TECHNICAL INFORMATION

Date: 28.06.2022
TI: 1022
Machine type/s: HG CVS 500,
HG 20 Trend
ES, HO
Siamonie
Smart

Alternative brewing valve

A&K Müller Valve

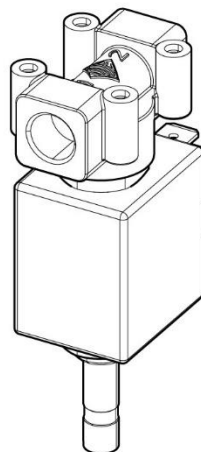
Due to the difficult procurement situation worldwide we have experienced problems in obtaining this key component. In order to continue to maintain the delivery chain, as a temporary measure, we are fitting an alternative brewing valve, which has been successfully used in the past in the production of all floor-standing machines with an espresso brewing unit and the Siamonie Smart.

From production week **KW 25/2022** machine serial number **90534422** the alternative brewing valve from A&K Müller will be fitted temporarily.

If a spare part is required for the machines affected, part number 409 00 940 00 solenoid valve 3/2 should be used for the A&K Müller valve. For machines produced before the date specified and fitted with an SFS valve, part number 414 00 941 00 solenoid valve 3/2 should be used.
